35th Guam Legislature

Committee on Health, Tourism, Historic Preservation, Land and Justice

RE: 6th Annual Guam Programmatic Agreement Workshop and Issues with the PA

Subject: Review of Revised PA Memo #2 J-755 Urban Combat Training Project – Construction of Training Areas (Andersen South)

Attachment 1

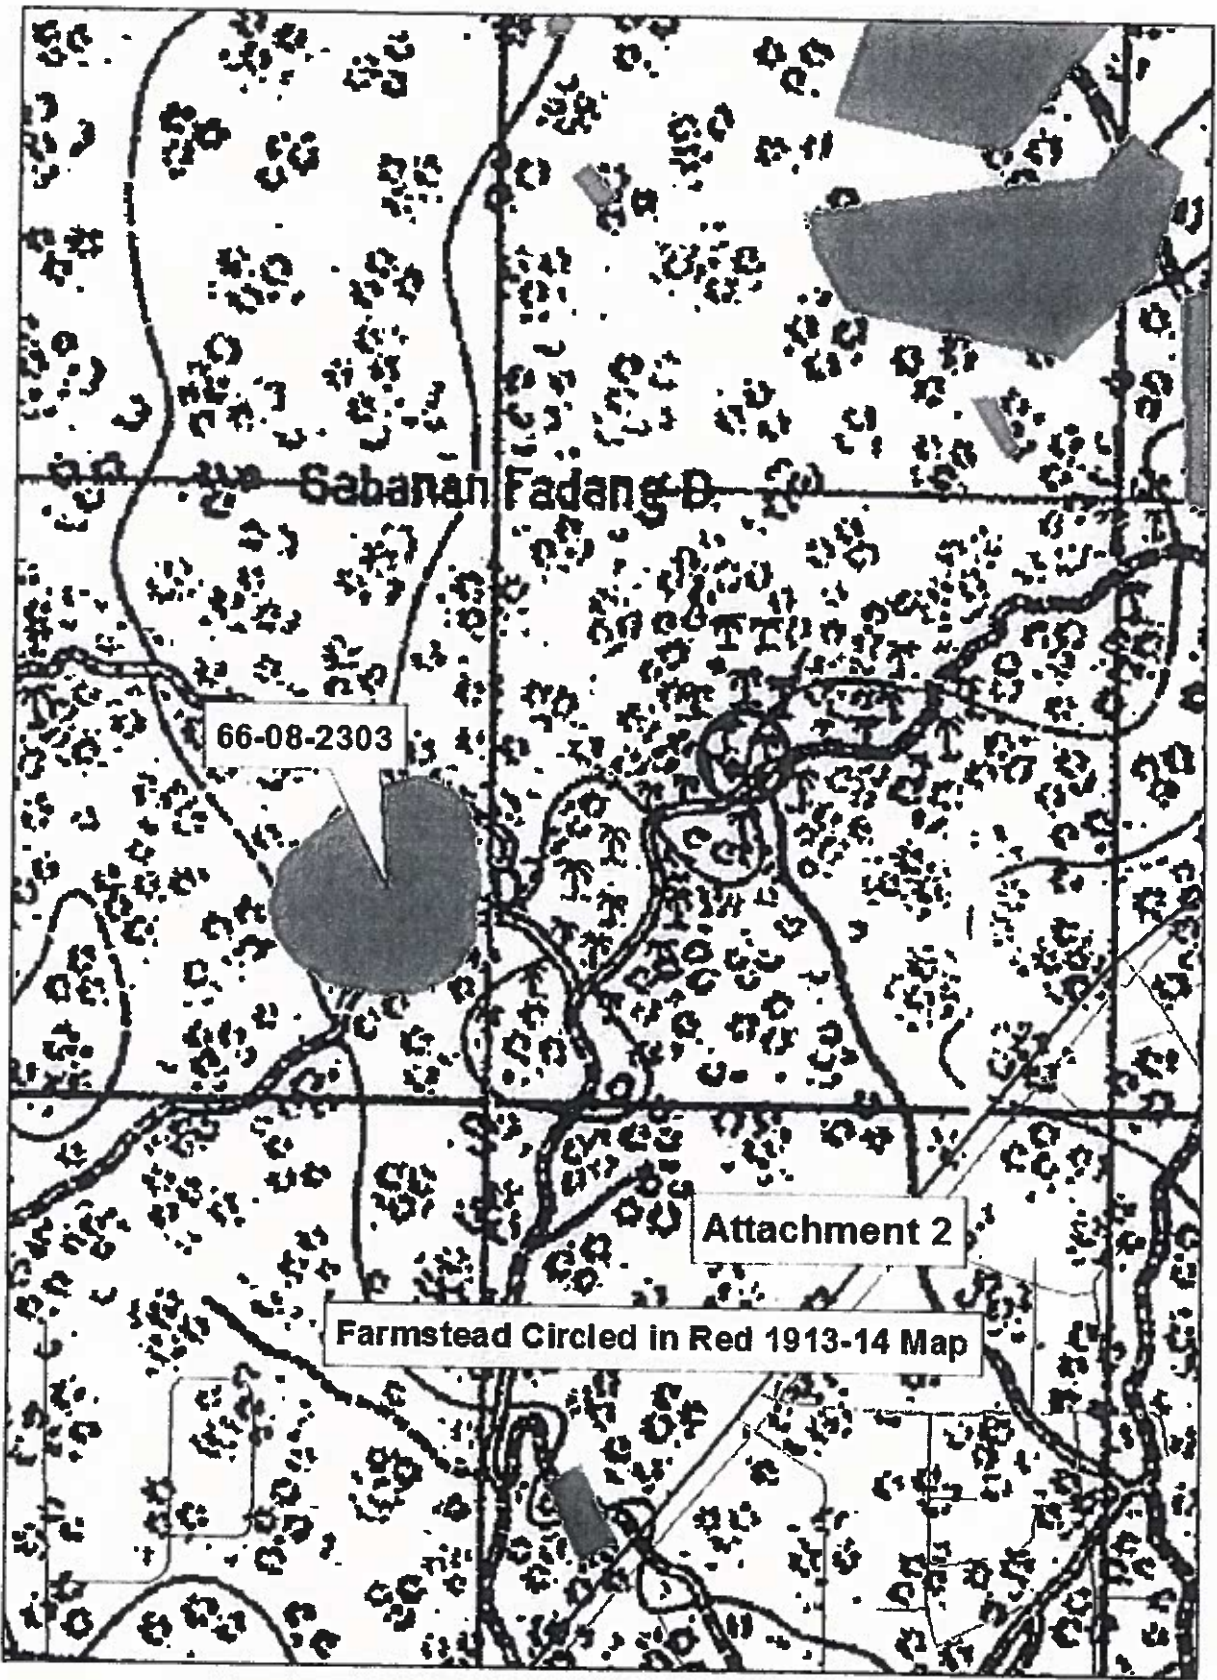
In reviewing the Welch 2010 report, and the other surveys listed in the PA Memo J-001B, the actual survey area does not cover the entire APE listed in Figure 1. The archival survey may have sufficed for the 2011 APE with its minimum impact, but this is not sufficient for the 2014 APE presented in the J-001B PA Memo. Welch's 2010 report also indicates that "field team was **not able to cover two areas** during the time allotted for the survey" (143, Vol.I), however, he **does** not indicate where these areas are located and the size of these areas. This is also compounded by Hiro Kurashina's survey with **transects varying between 90 and 180 feet**. We have marked a map Attachment 1, indicating the areas not previously surveyed during the 2010 report that need to be surveyed by boots on the ground. These areas are colored in black and marked with + symbols. The survey should also include systematic subsurface testing. The testing may provide more information and possibly expand the boundaries of sites 66-08-2303 and 66-08-2302 since the un-surveyed areas about these sites.

Farmstead Circled in Red 1944 Map

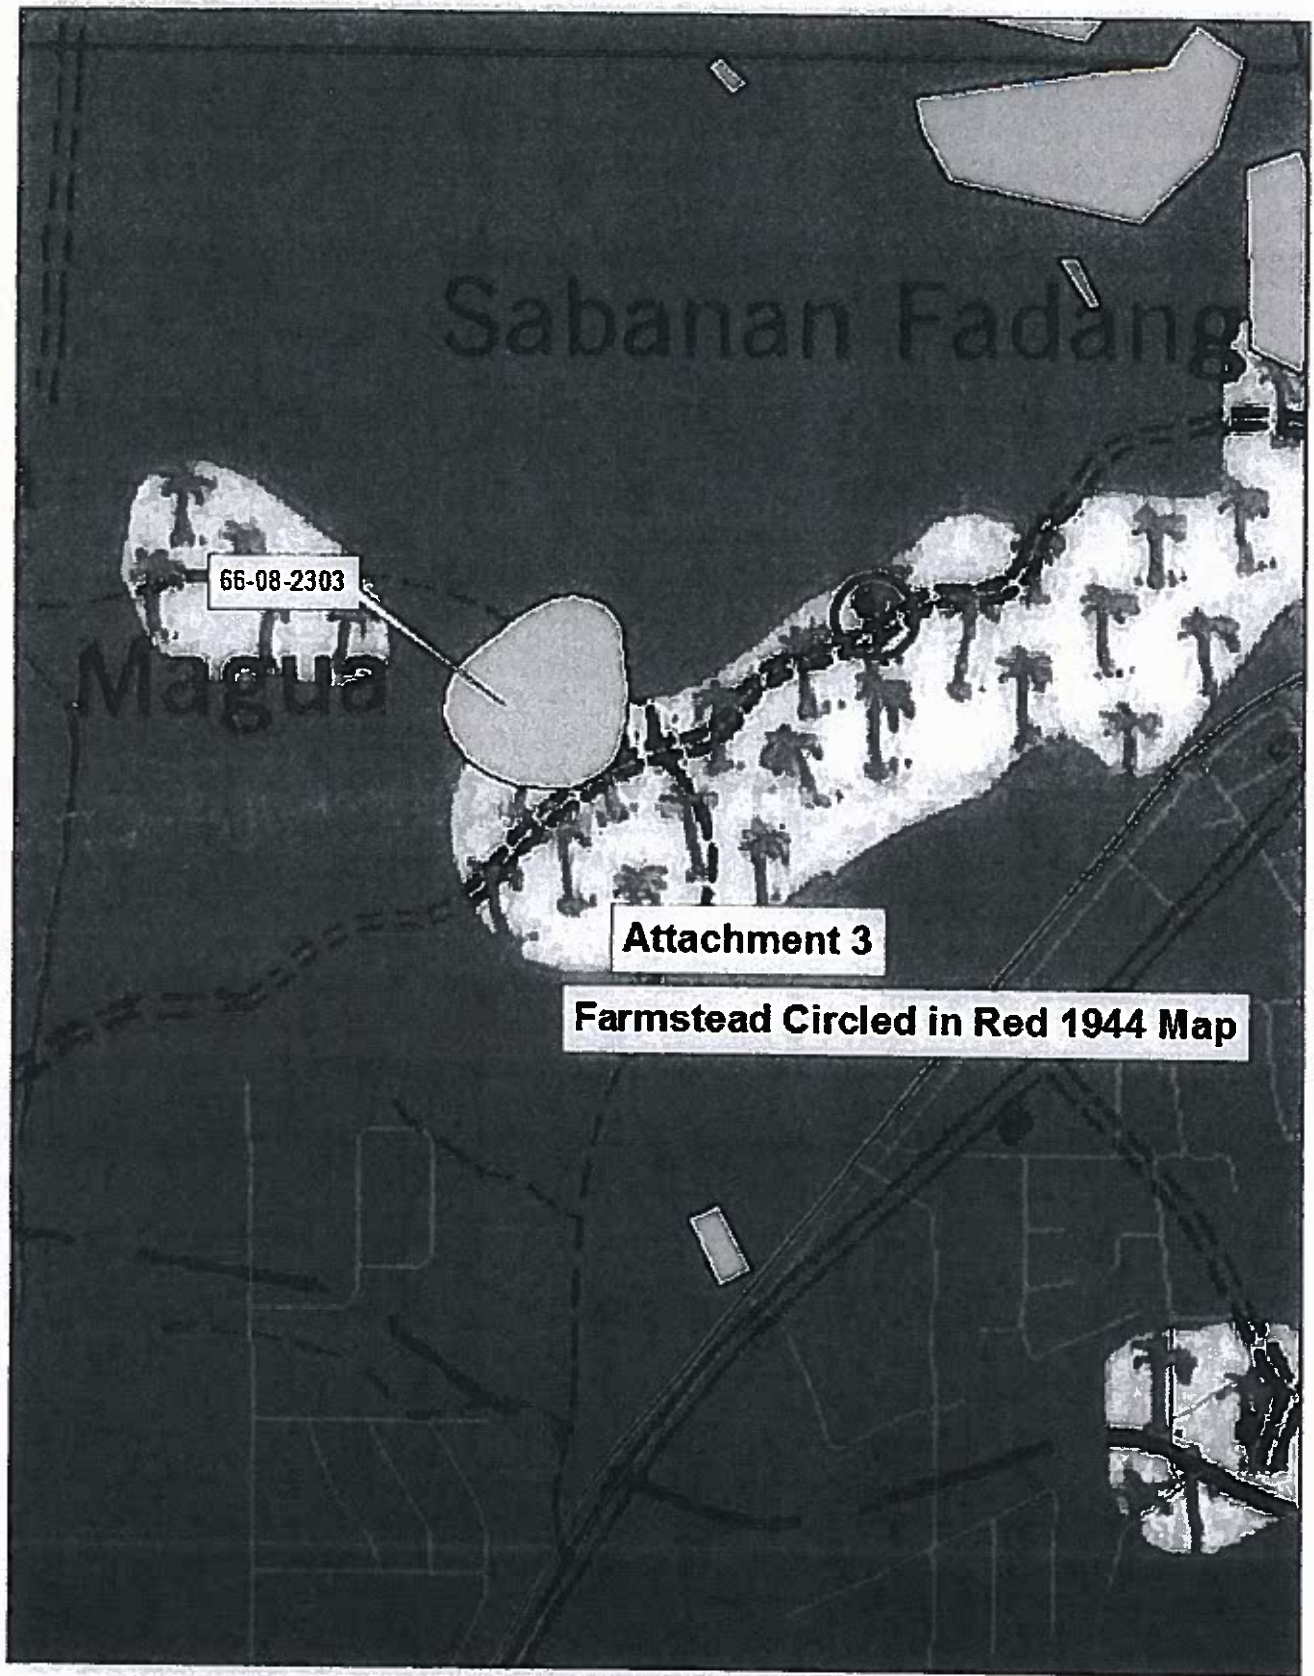
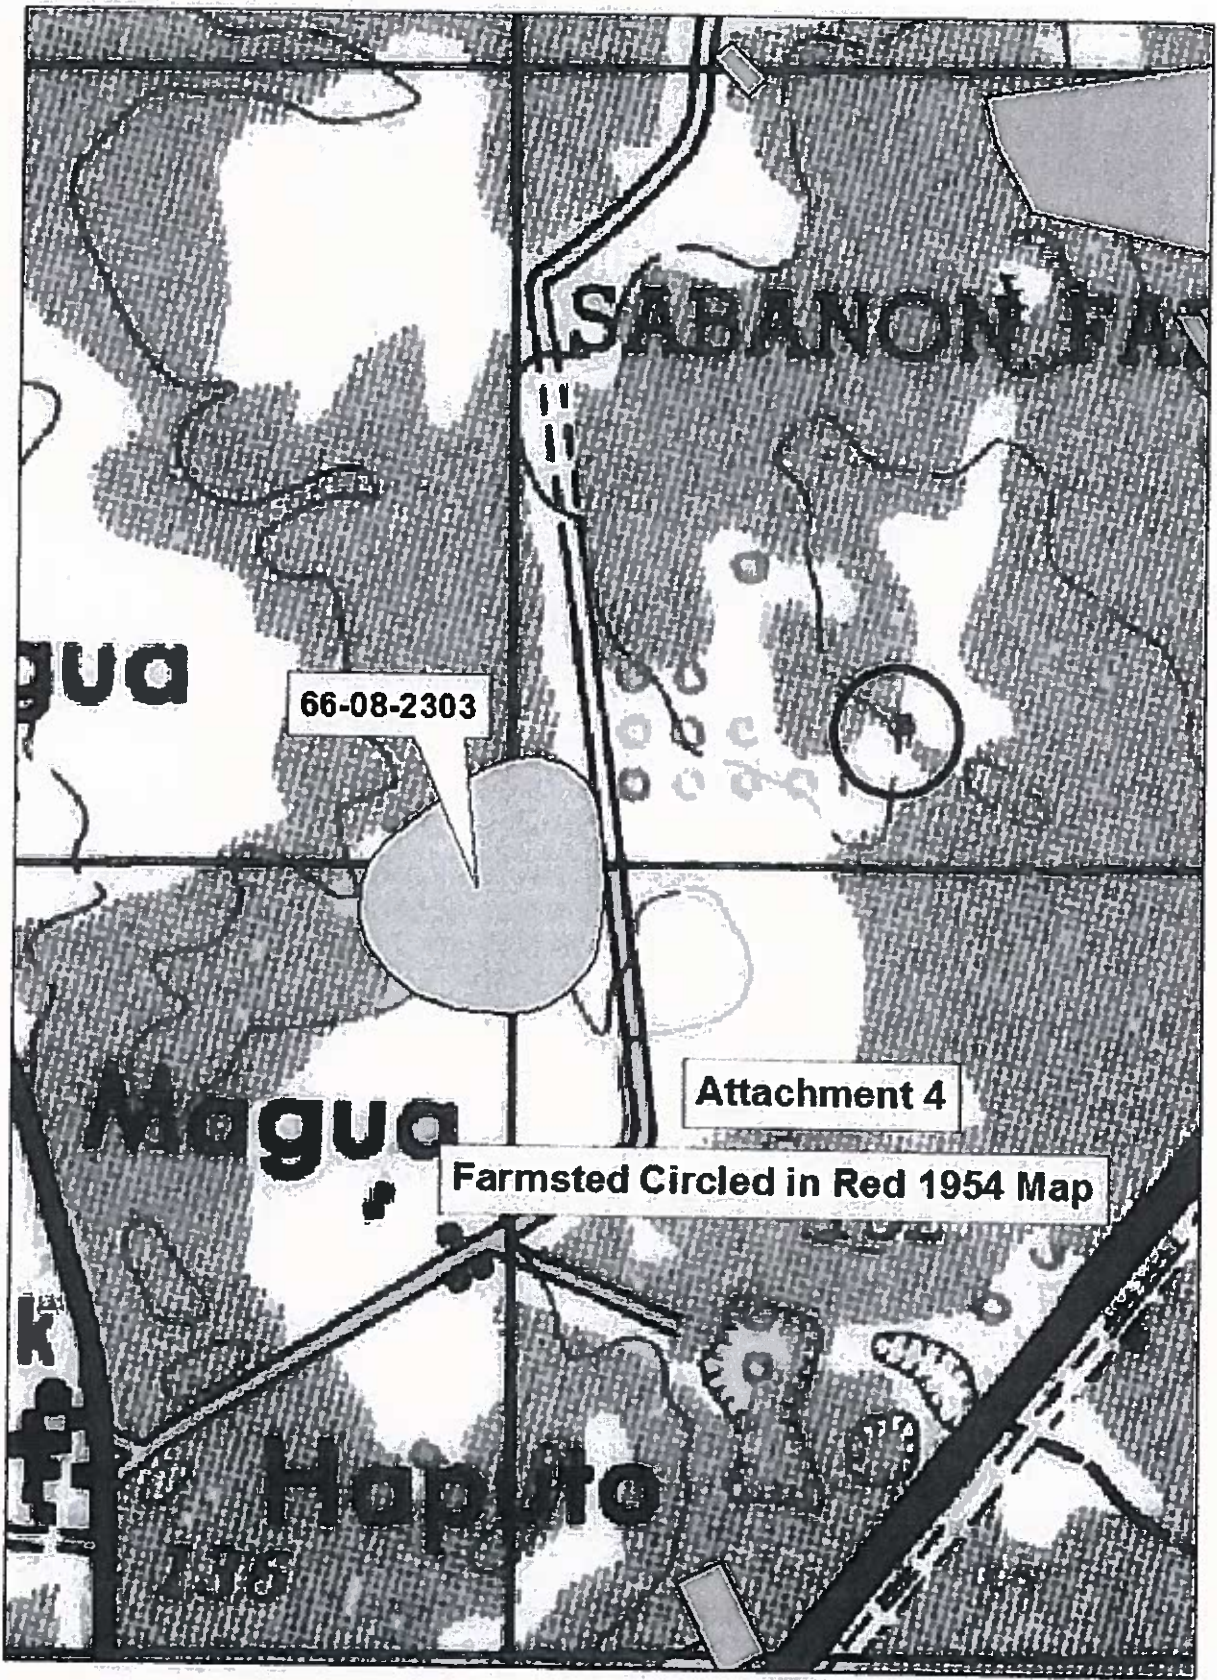
In reviewing the historical maps of the APE, we identified a farm site not located during Welch’s 2010 survey that survived for 40 years on the historical maps. This site appears on three historical maps, the 1913-14, the 1944 and the 1954 maps circled in red (Attachments 2, 3, and 4). We find no discussion of this site in the Welch’s 2010 report in the background research, or why it wasn’t located on the landscape. The site being historical in nature should be easily identifiable due to its age and associated trash dumps. This site could also be a part of the *Magua* Coconut Plantation.

**Andersen South J-755 APEs
(Construction and Operations)**

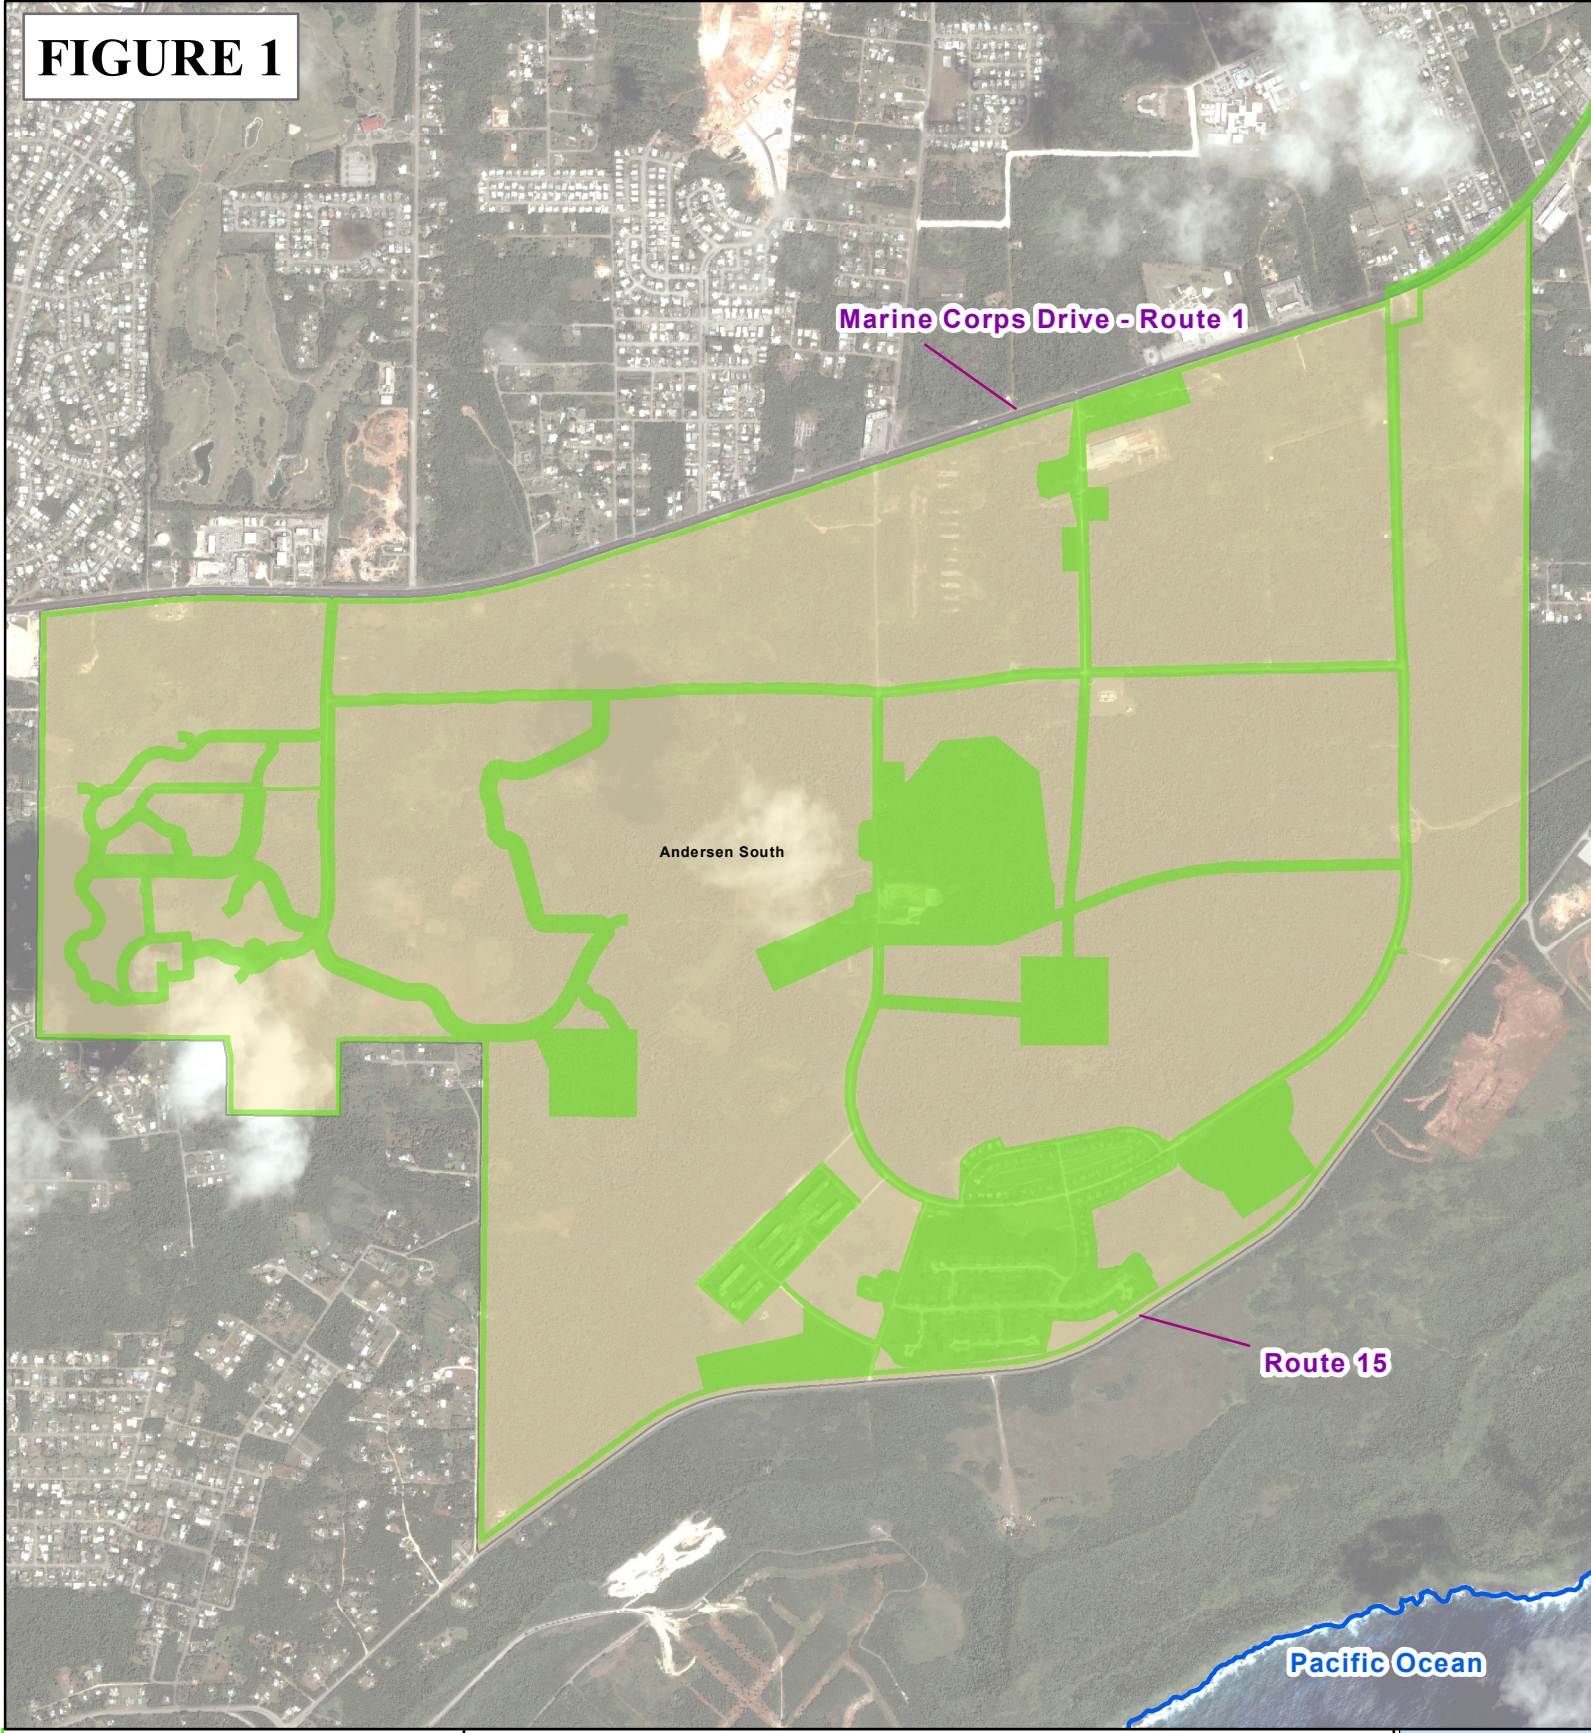
We believe that the Operations and the Construction of J-755 should not stand alone or be separated and if reviewed as such, our findings will result in an adverse effect determination. Therefore, we will anticipate another PA Memo for Operations in due time. This is analogous to constructing a new house - approvals on construction plans are gathered, then an "Occupancy Permit" issued. The Occupancy Permit is withheld if there are changes contrary to what's been approved. Section 106 or the 2011 Programmatic Agreement process does not defer "to a later date" (pg. 3 PAM), on the identification of sites that may potentially be eligible for listing on the National Register of Historic Places (NRHP). Though you are separating the Construction and Operations, we are considering both under one APE (Area of Potential Effect), and not two APEs as intimated, unless they are revised under another Revised PA Memo.
